# *Super Stearman*

## Great Planes Super Stearman EP ARF Addendum

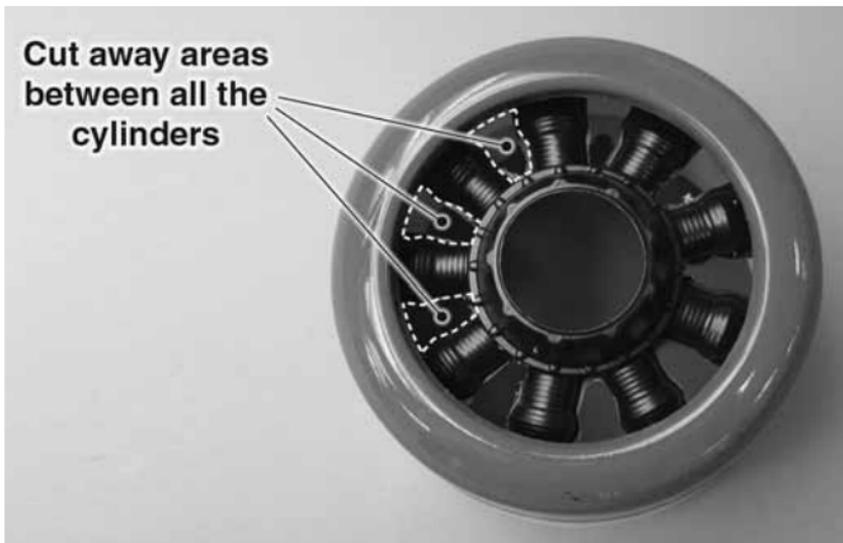
To prevent motor overheating when flying in warm weather we recommend that you cut the area away between the cylinders of the dummy engine. This is best accomplished by cutting the material with a hobby knife or Dremel Tool, cutting inside the cowl and cutting the material away from the back side of the dummy engine.
